Docket Number:	08-AFC-03C
Project Title:	Marsh Landing Generating Station Compliance
TN #:	203085
Document Title:	NRG Marsh Landing's Responses to Data Requests 1-3
Description:	N/A
Filer:	URS
Organization:	URS
Submitter Role:	Applicant Consultant
Submission Date:	9/19/2014 3:34:21 PM
Docketed Date:	9/19/2014

RE: Marsh Landing Generating Station
Petition to Amend (08-AFC-03C)
Responses to Data Requests 1 - 3

Technical Area: Soil and Water Resources

PIPING AND INSTRUMENTATION DIAGRAM
 FPS - FIRE PROTECTION

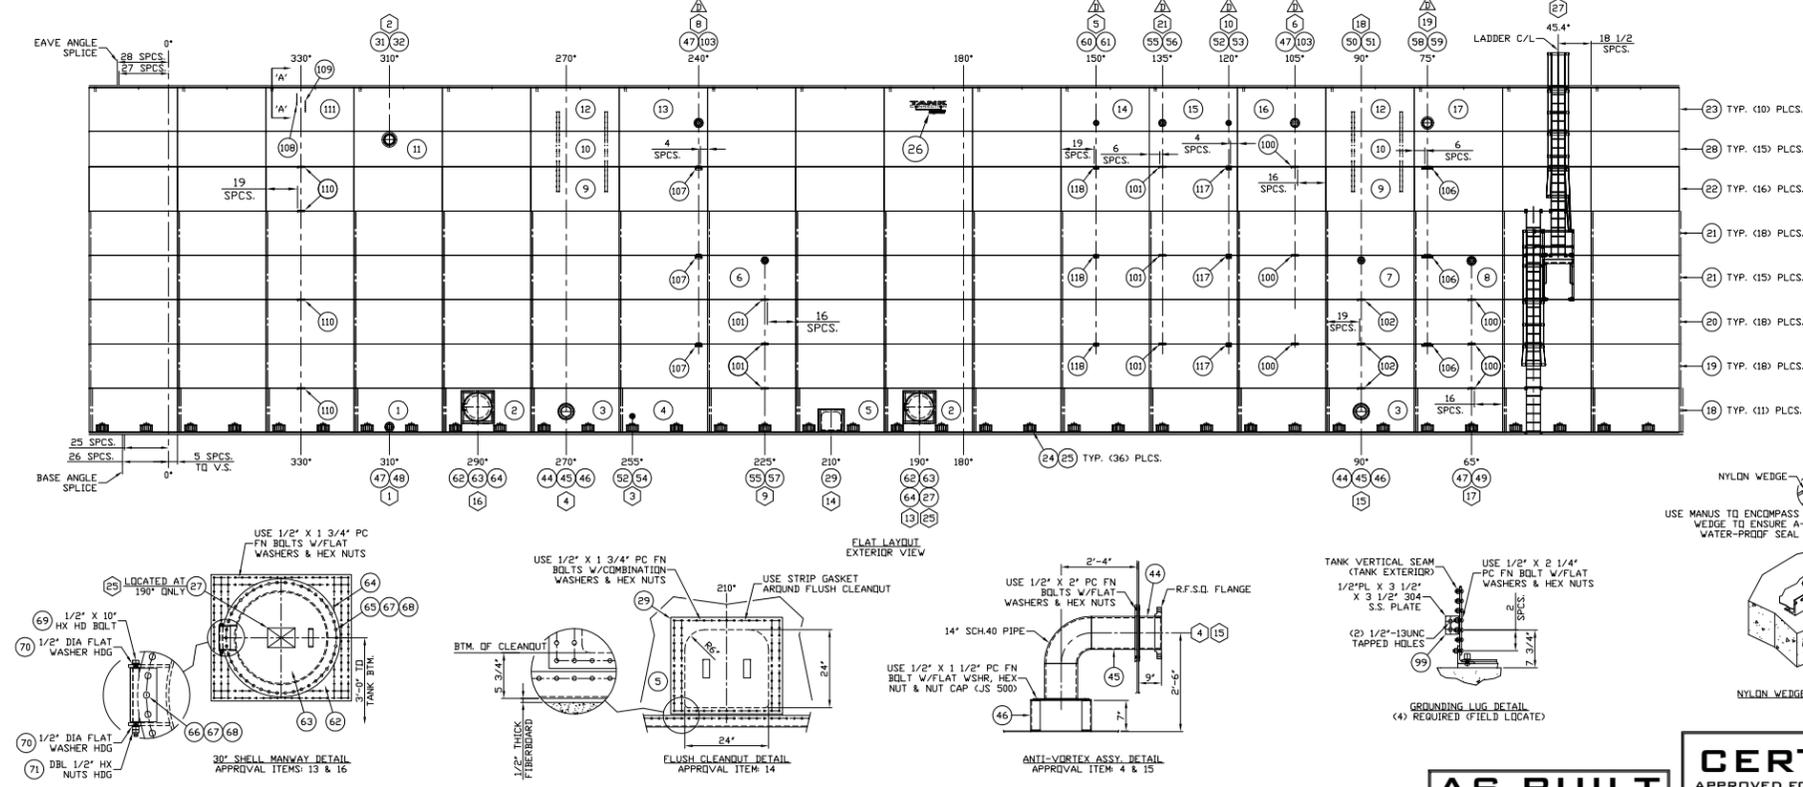
- 3. Please provide a detailed construction drawing showing the location of the piping where it would be above ground and below ground from the diesel pump to the raw water storage tank and where the piping would connect to the existing onsite fire suppression system.**

There are no detailed piping drawings at this time. The attached Piping and Instrumentation Diagram (Figure 3-1) shows the tie in points for the future system. The Raw Water Storage Tank drawing (Figure 3-2) shows connection numbers 4 and 19 are for future fire water piping (see Accessory Orientation Chart). These are the only drawings that NRG Marsh Landing has available at this time.
